Draft Road Management Plan 2021 Submissions and Officer Responses

RESPONSE TO DRAFT ROAD MANAGEMENT PLAN 2021

Prepared by: Streets Alive Yarra Inc.
streets-alive-yarra.org

4. Performance Standards

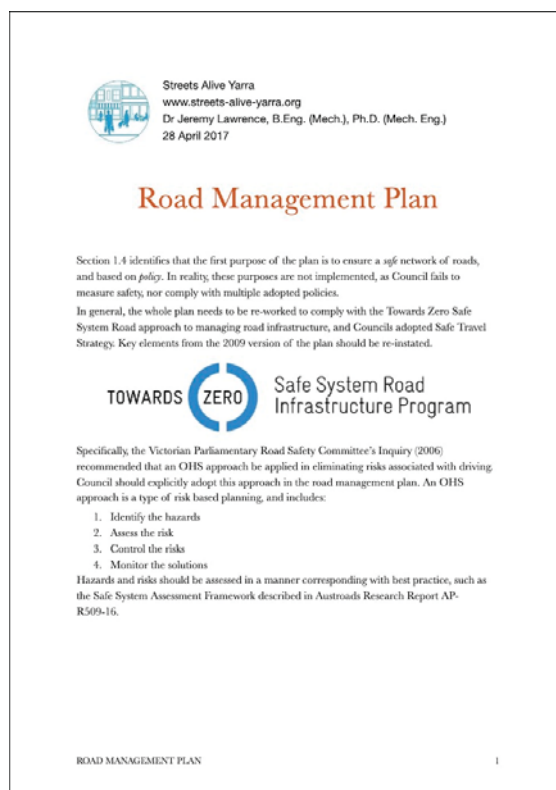
The draft states that the number (1) objective is to “ensure public safety”; but fails to describe a process to deliver this.

The #1 performance standard is to ensure public safety

The primary failure of the draft is that it assumes the design drawing for a road is “safe” and thus only proposes to detect defects that represent a difference between the design drawing and reality. What the draft should do is identify problems with the design of the road. In our opinion, a road that is poorly designed is a “defect” or a “condition” that is an assessable “hazard”.

Process to ensure public safety. Image credit: iRAP.

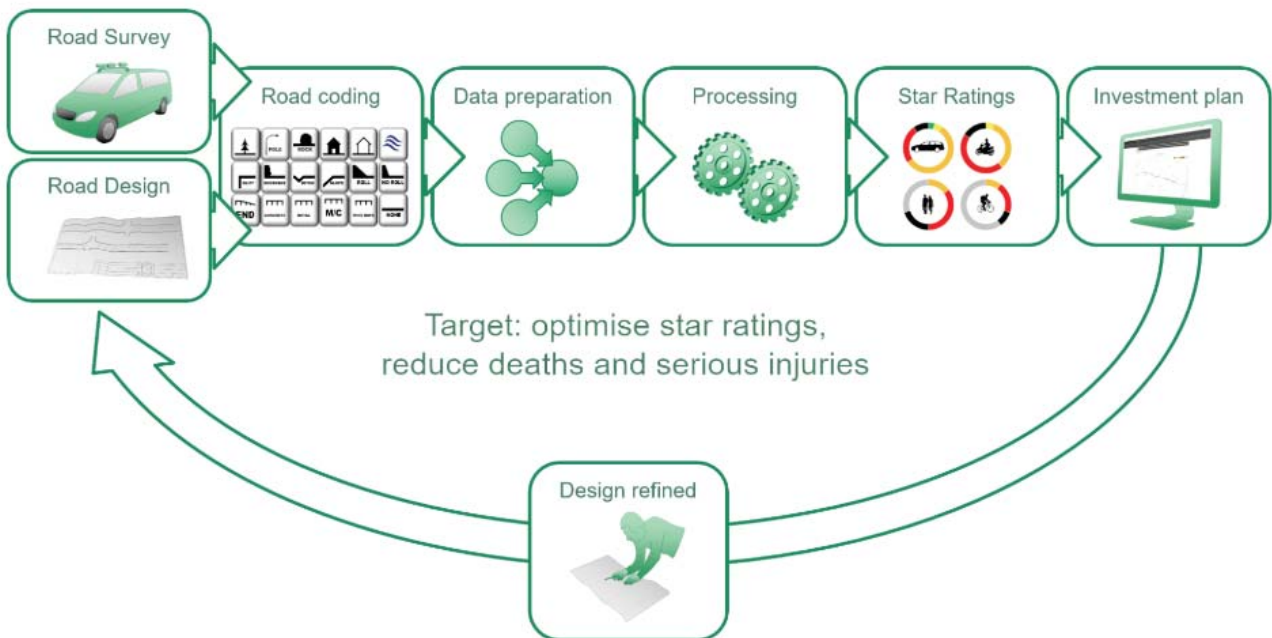
A best practice solution to “ensure public safety” would involve:

- Identify the hazards
- Quantify the risks
- Mitigate the risks
- Monitor the solutions

These concepts are also described on a page on our website: <https://streets-alive-yarra.org/safety/>. A best practice process would be to give a star rating to each road, then work to improve star ratings.
